PRODUCT BULLETIN #20811

Issue Date: 09-Mar-2015

TITLE: NCV8876 Datasheet Update

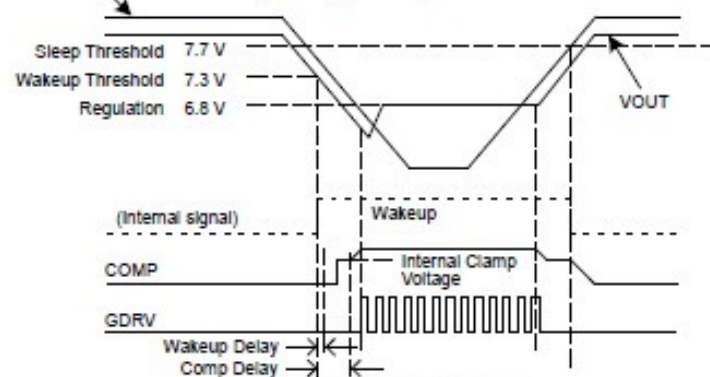
A good design practice recommendation of a MOSFET gate-source resistor on the PCB has been added to the datasheet. This resistor prevents the MOSFET from turning on in case of a floating gate.

The recommended resistor has been added to the application drawing on page 2, and a comment is added in the pin description. See below for highlighted changes to page 2.

Pin No.	Pin Symbol	Function
1	STATUS	This is an open-drain diagnostic. IC status operation flag indicator. This output is a logic low when IC VOUT is below 7.3 V and device is active. A pull-up resistor of around 80 kΩ should be connected between STATUS and a microcontroller reference. This output is a logic high when the IC is disabled or in UVLO.
2	ISNS	Current sense input. Connect this pin to the source of the external N-MOSFET, through a current-sense resistor to ground to sense the switching current for regulation and current limiting.
3	GND	Ground reference.
4	GDRV	Gate driver output. Connect to gate of the external N-MOSFET. A series resistance can be added from GDRV to the gate to tailor EMC performance. An $R_{GND} = 15\text{ k}\Omega$ GDRV-GND resistor is strongly recommended.
